La Jolla Shores Planned District Advisory Board (LJSPDAB) APPLICANT PROJECT INFORMATION FORM

- Project description: **CONSTRUCTION OF A NEW 8,025 SF SINGLE FAMILY RESIDENCE, TWO-STORY DWELLING UNIT OVER BASEMENT WITH GARAGE, SPA, SITE RETAINING WALLS, AND ADDITIONAL SITE IMPROVEMENTS**

MONTORO ESTATE

Site development Plans: Lot 2: Montoro Estates, San Diego, California, prepared by Island Architects, dated May 1, 2025; structural plans by Harris & Sloan; civil plans by Project Design Consultants.

WEST ELEVATION
SCALE: 1/8" = 1'-0"

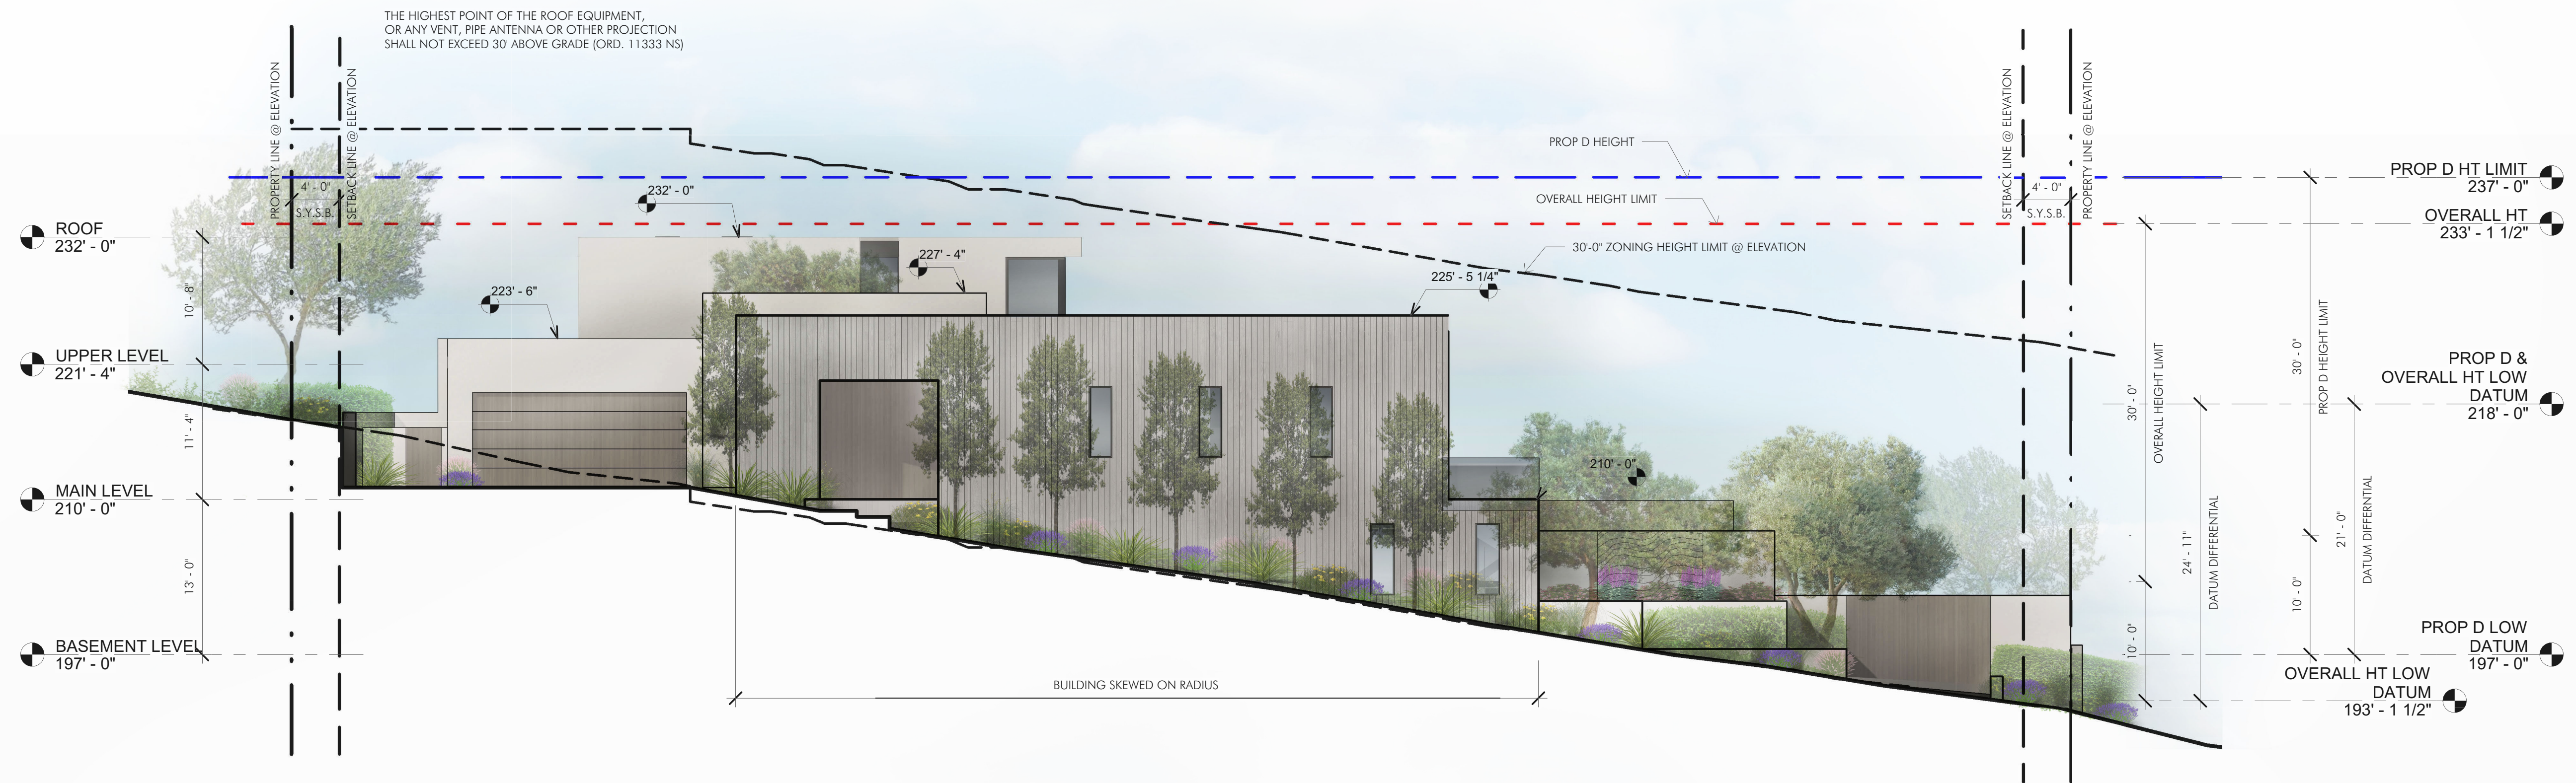
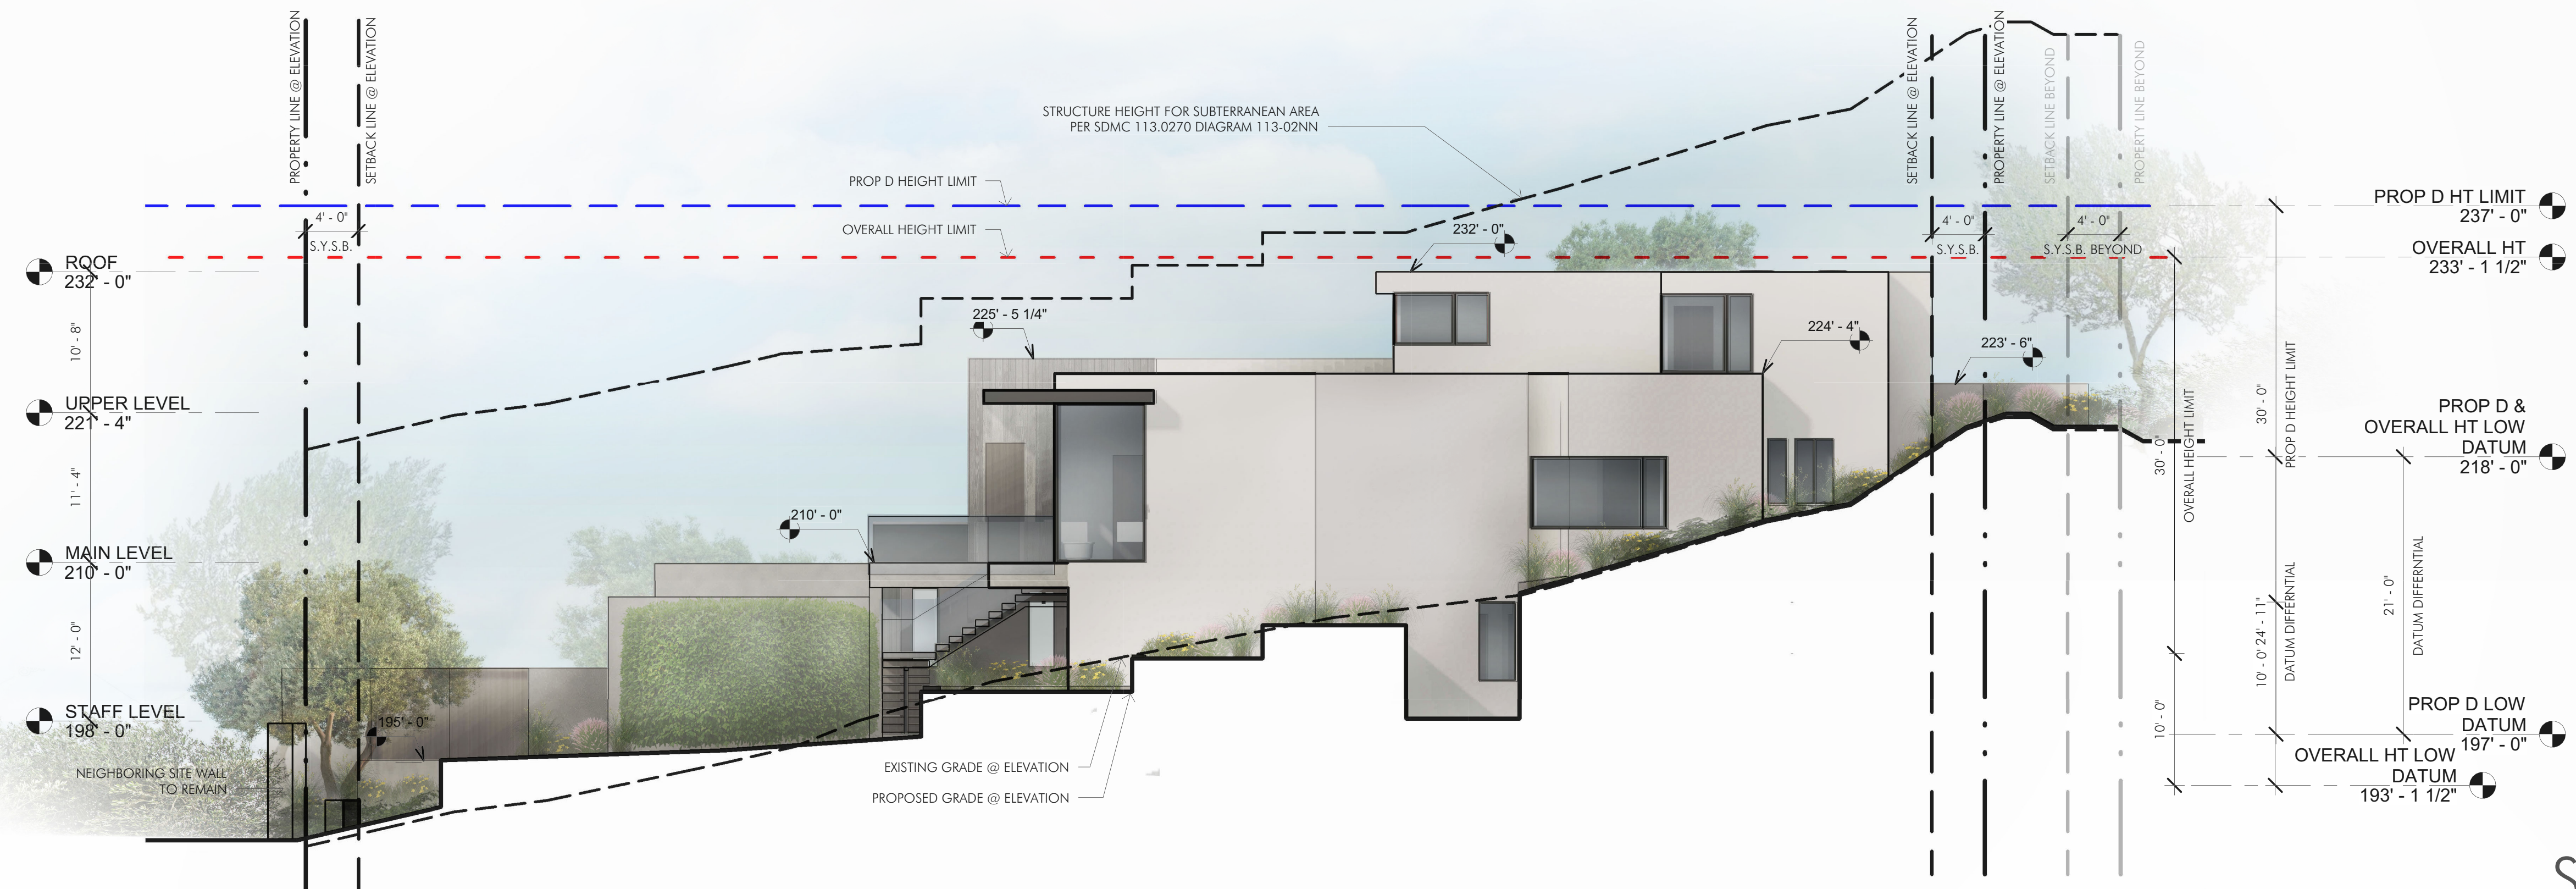
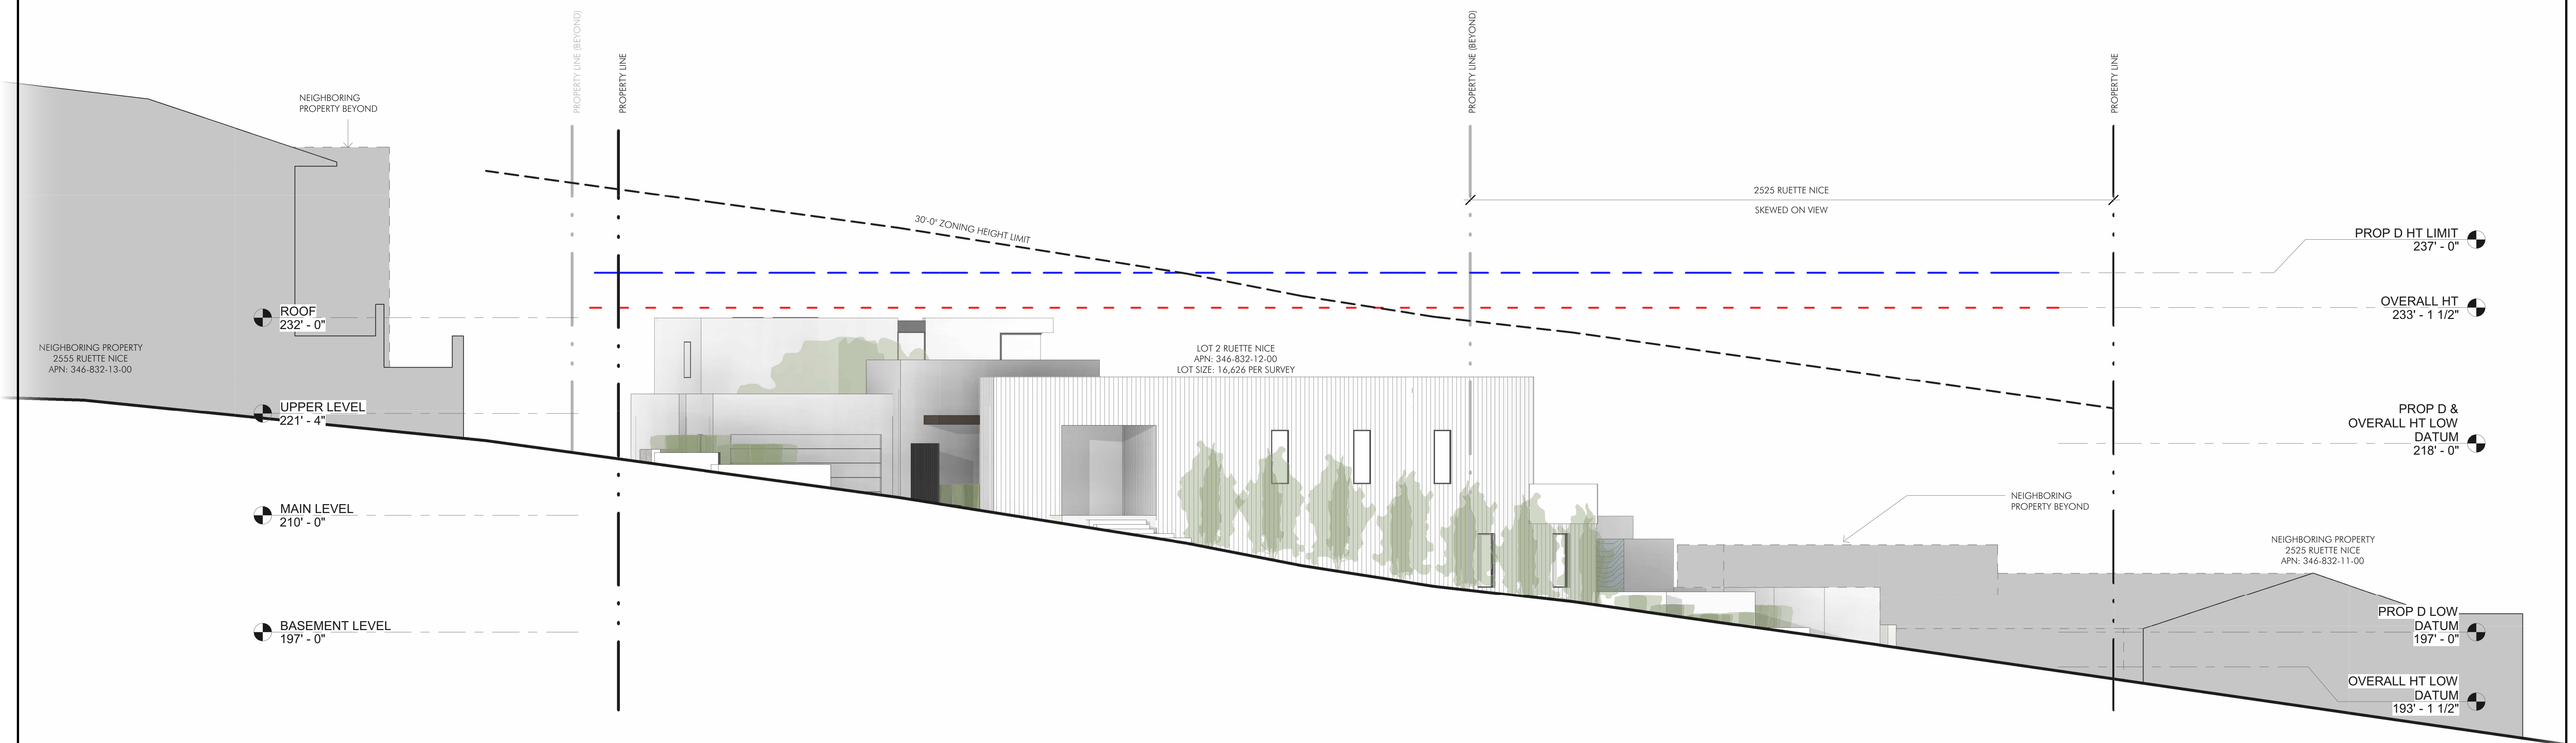
17. Clearly label the ground floor on all elevation and section plans to indicate whether it reflects existing grade, proposed grade, or both. Use two different colors (other than those already used to show height) to differentiate between the existing and proposed grade lines. This will help clarify how the plumb line height is being measured.

18. Clarify how the imaginary plane line is being extrapolated from both the existing and proposed grade to determine the plumb line height. Use two distinct colors to differentiate between the existing and proposed grade lines, as noted in the previous comment, to clearly demonstrate the measurement method.

Hose Pull:

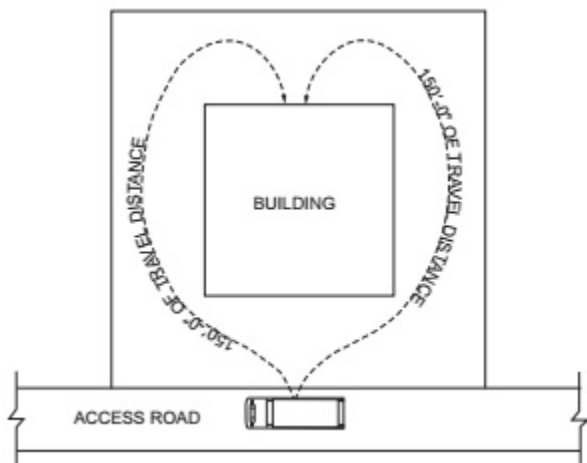
All portions of the exterior perimeter of new buildings shall be within 150' (non-sprinklered) or 200' (sprinklered) of a fire access road. Show hose pull on plans as pictured below. Note: Fire will add 8' to hose pull calculation to account for private vehicles parked on the street.

CODE - CFC 503.1.1 Buildings and facilities. Approved fire apparatus access roads shall be provided for every facility, building or portion of a building hereafter constructed or moved into or within the jurisdiction. The fire apparatus access road shall comply with the requirements of this section and shall extend to within 150 feet (45 720 mm) of all portions of the facility and all portions of the exterior walls of the first story of the building as measured by an approved route around the exterior of the building or facility.
